**ADDENDUM NO. 1**

PROJECT: Winslow HVAC Systems Upgrades – School #5 ES9782.01

BID NO.: 2025-07

PARTIAL FIRST FLOOR DEMOLITION POWER PLAN - BLOCK B  
 1/8" = 1'-0" (1 ED11B)

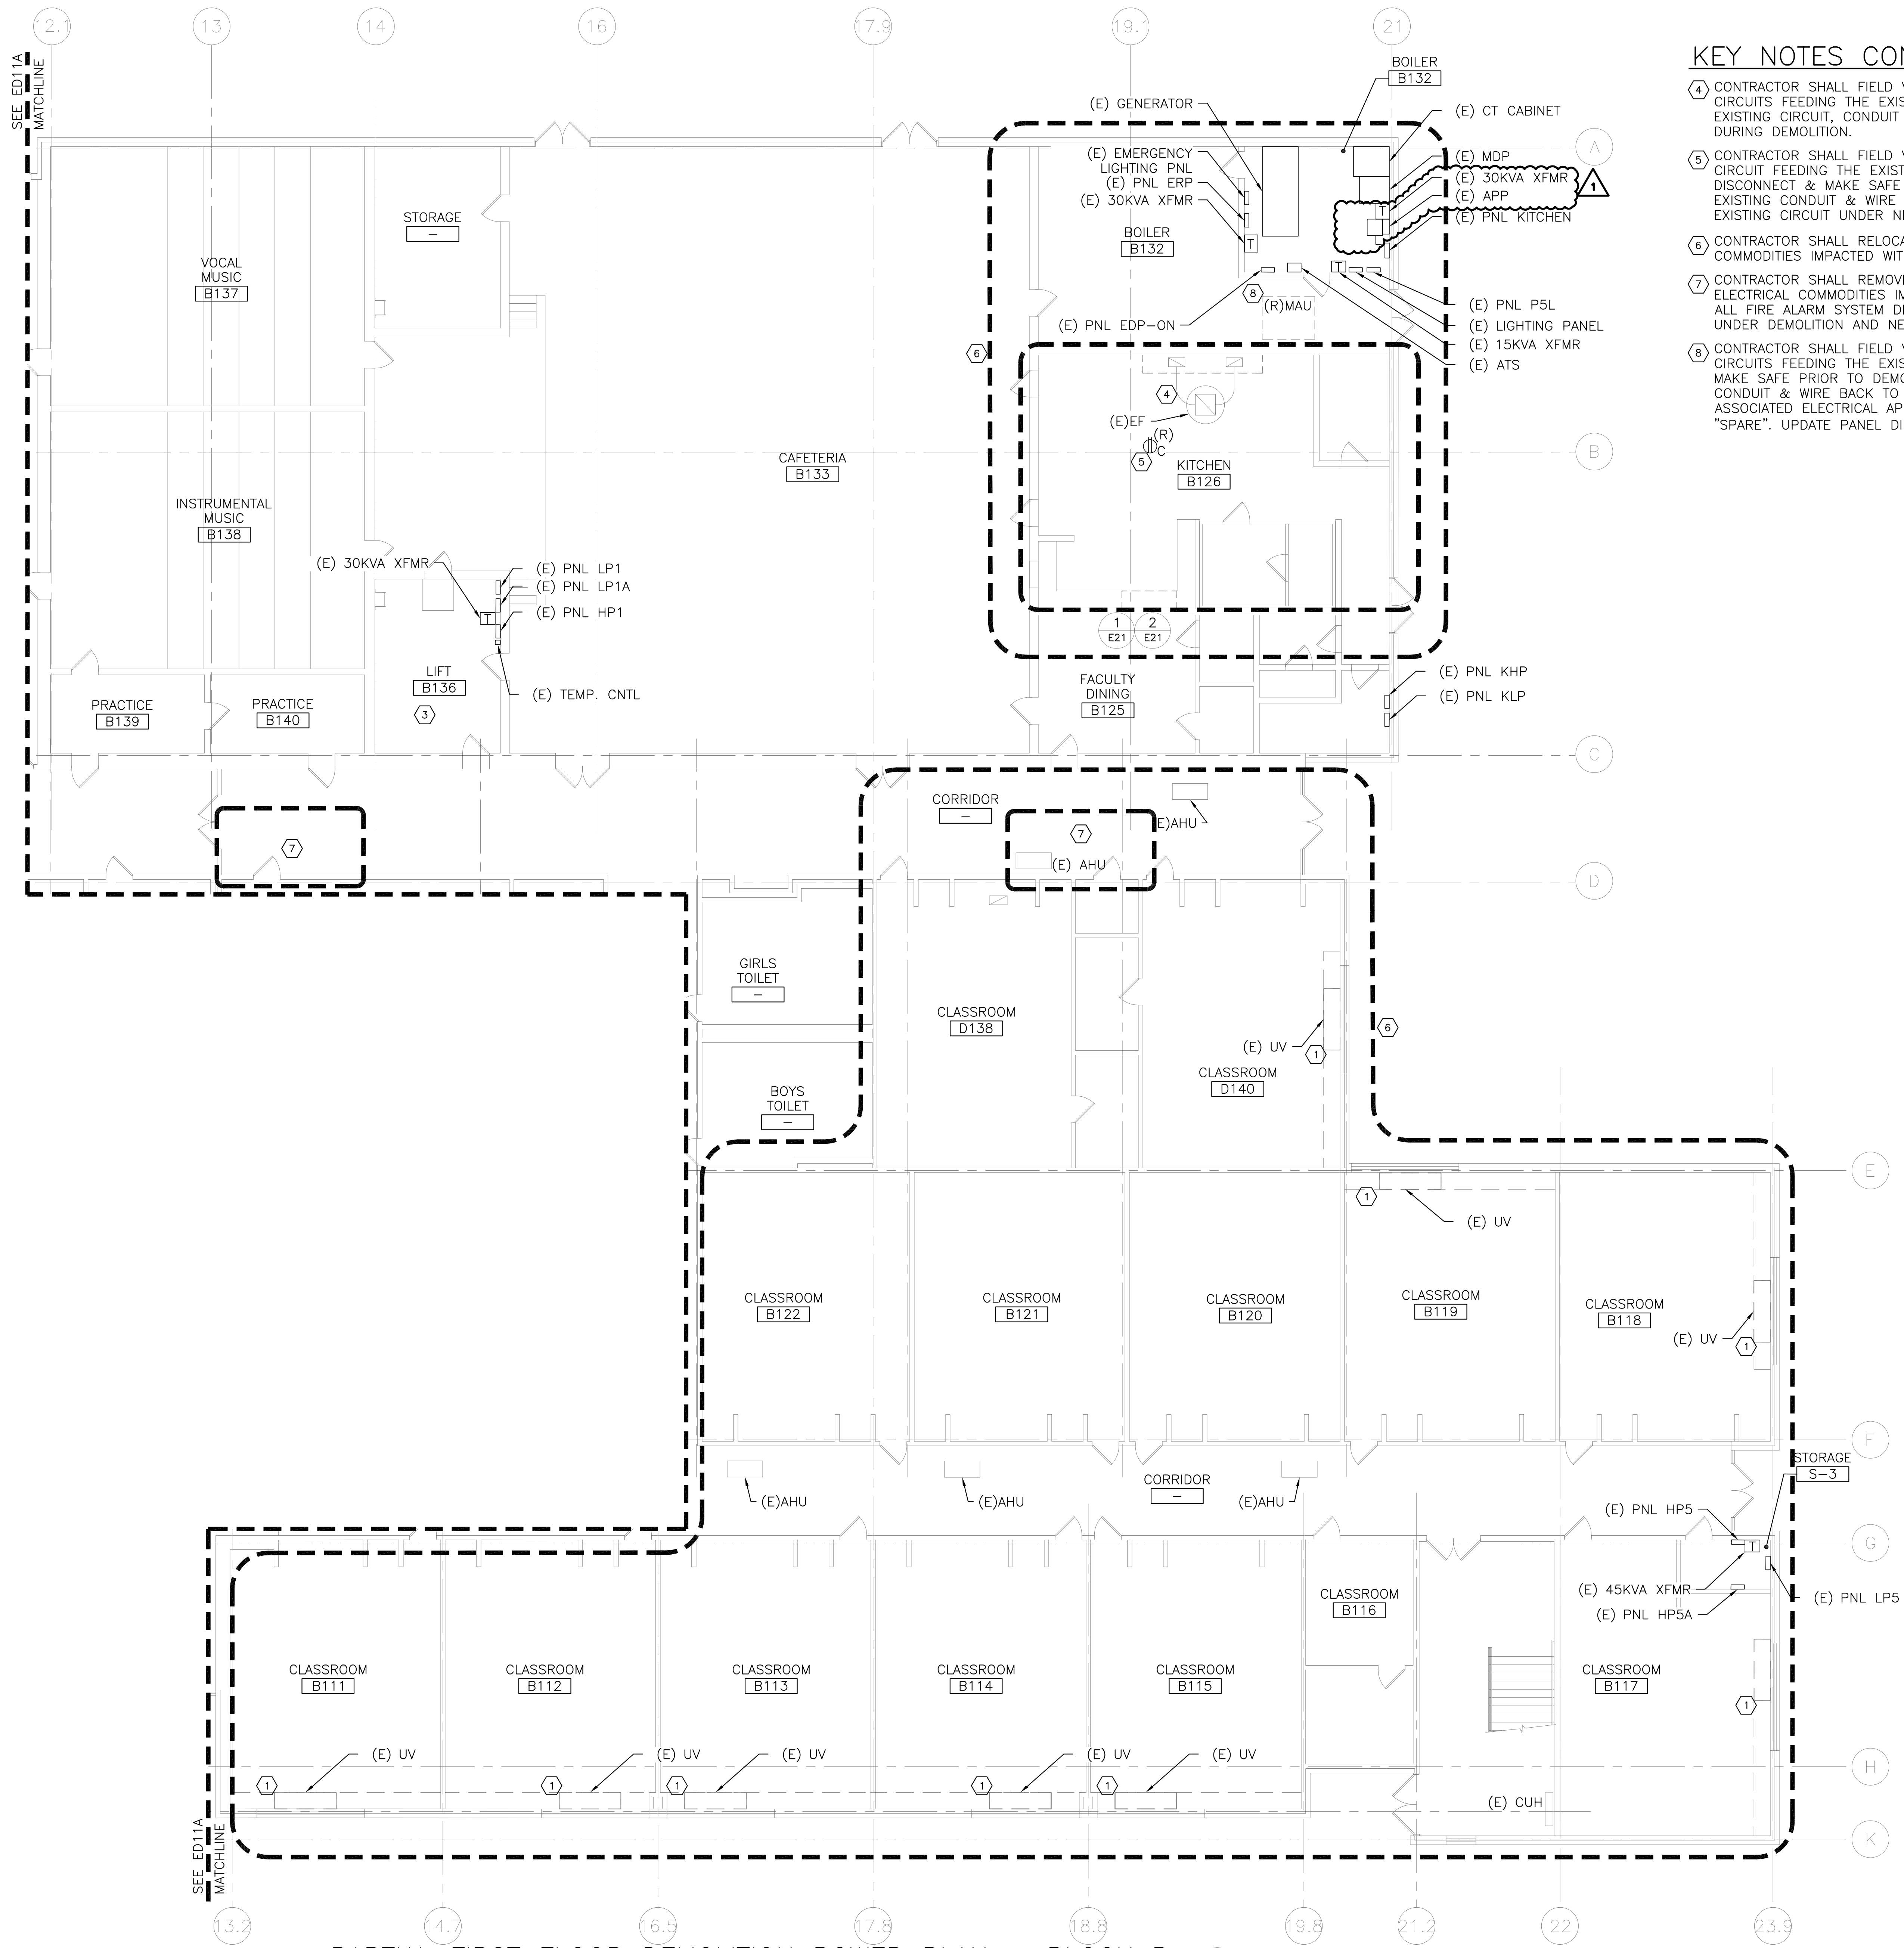
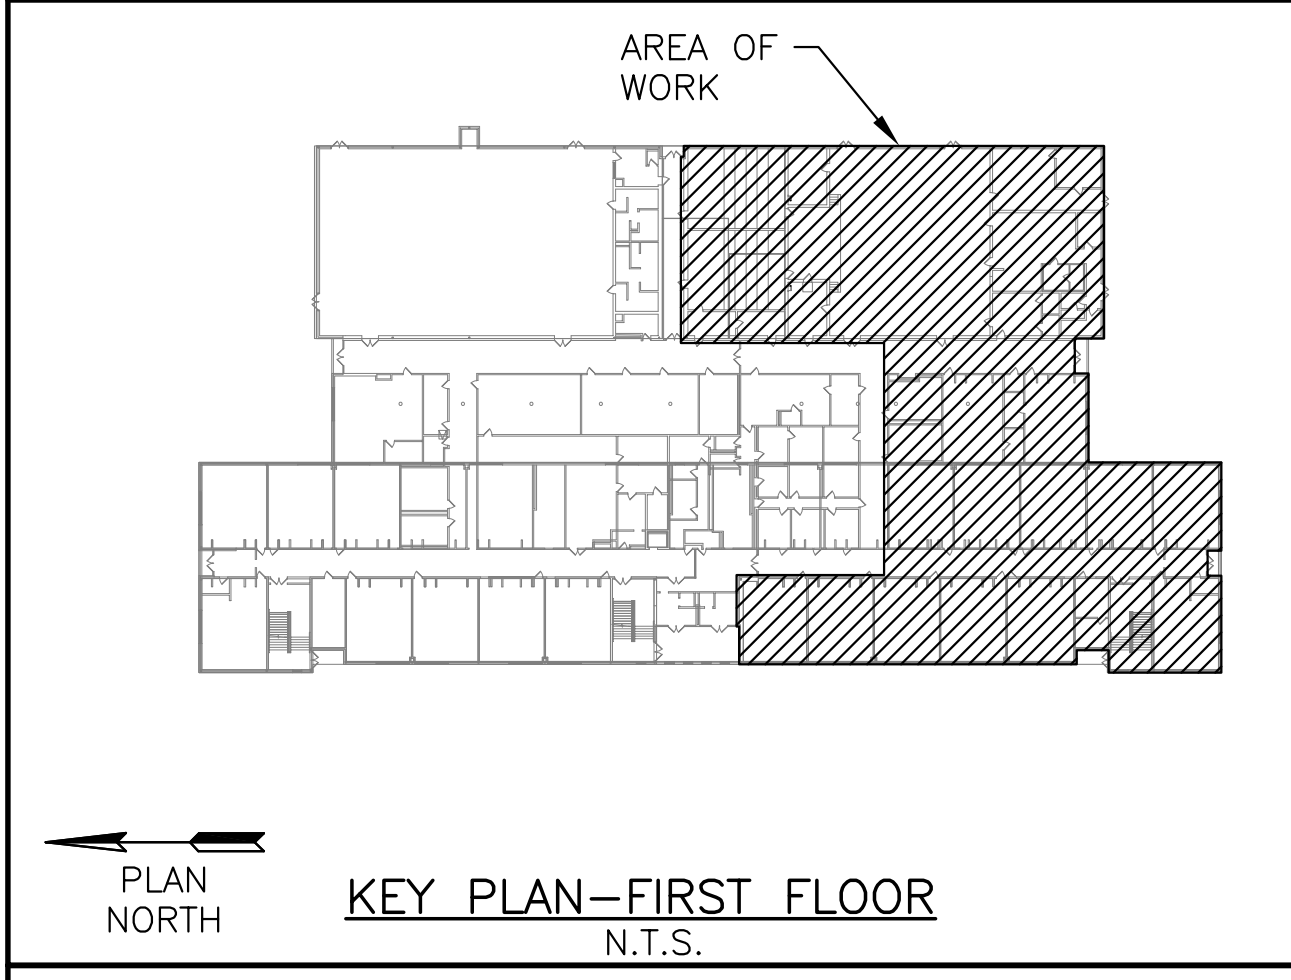
**9. Q: Sheet #ED 11B - Remove 30KVA Transformer and Remove ATS (Why are these being removed)**
